Explanation of Significant Differences to the Final Record of Decision for Parcel C

**Hunters Point Shipyard
San Francisco, California**

October 2014

**RESPONSE TO COMMENTS ON
DRAFT EXPLANATION OF SIGNIFICANT DIFFERENCES TO THE
FINAL RECORD OF DECISION FOR PARCEL C, HUNTERS POINT NAVAL
SHIPYARD, SAN FRANCISCO, CALIFORNIA**

FIGURE
4-14

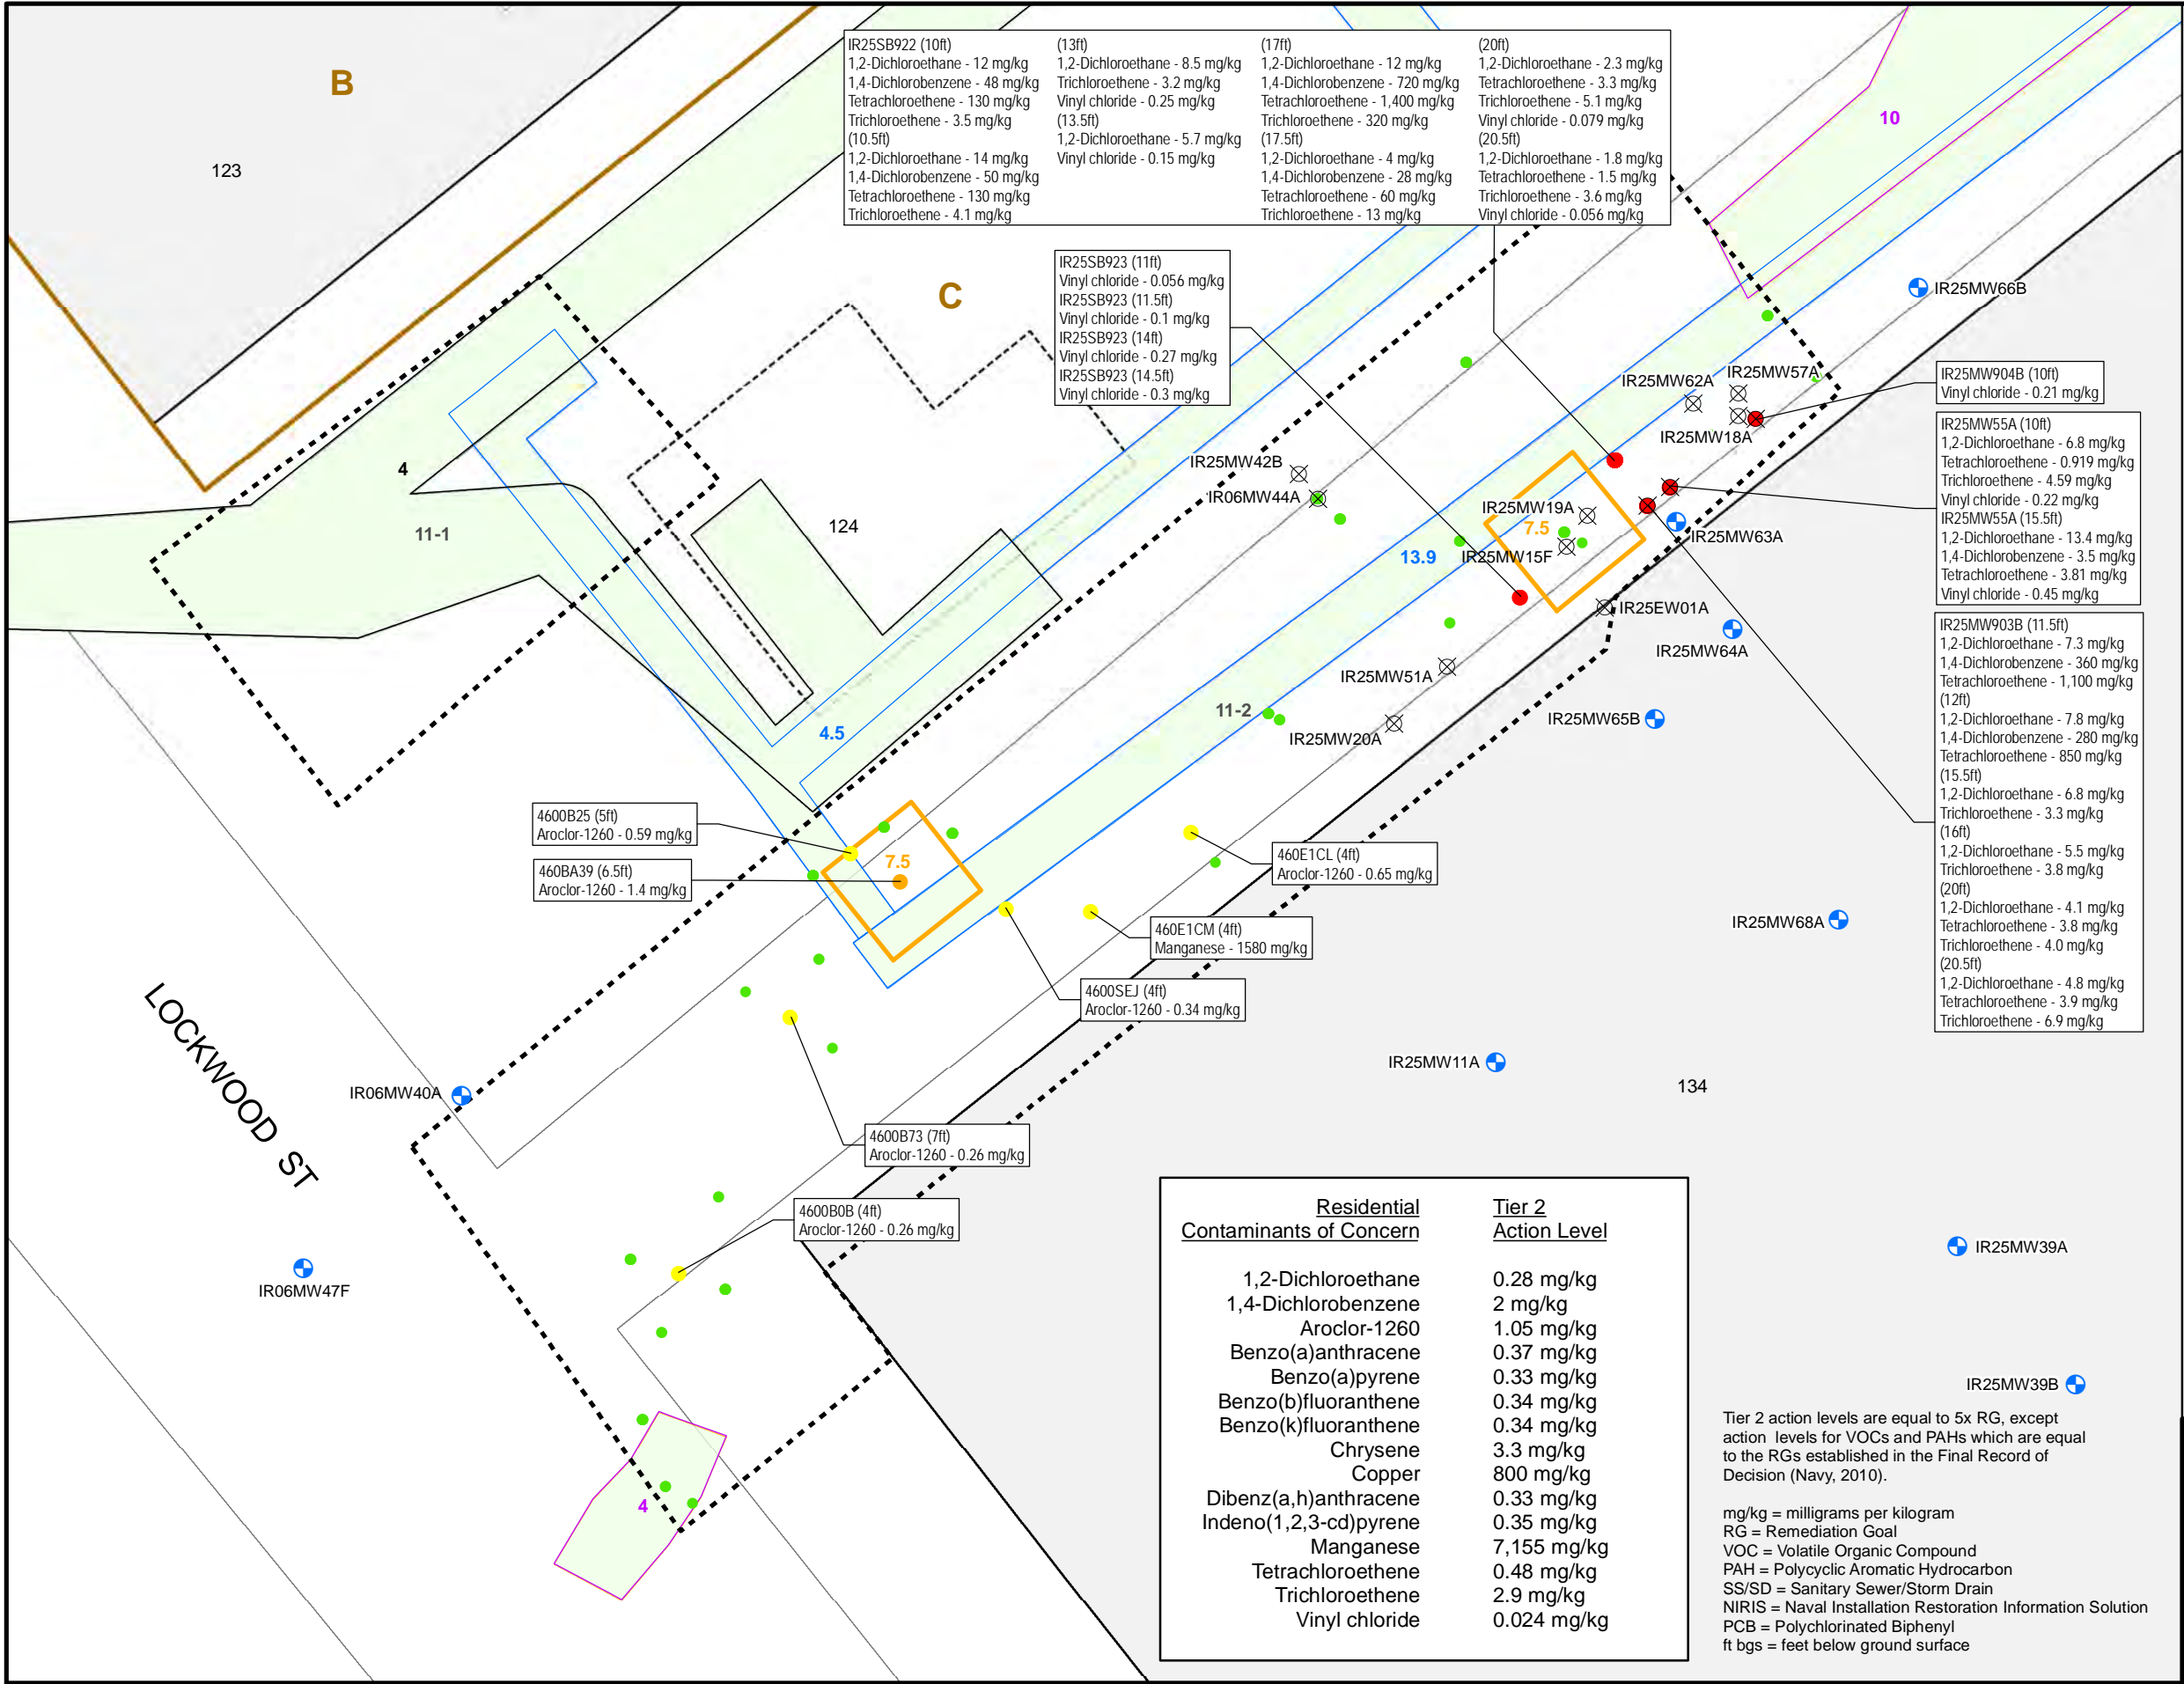
4.	Section 4.2.3 – RU-C5. Soil Excavation 11-2 subsection. Last paragraph.	The text states that a second 10-foot by 10-foot area will be excavated to 3.5 feet below ground surface (bgs), but the corresponding Figure 4-14 has this area labeled as a 7.5 feet bgs excavation. Please correct the text / figure accordingly.	The last sentence of Section 4.2.3 has been edited to say 7.5 feet bgs instead of 3.5 feet bgs.
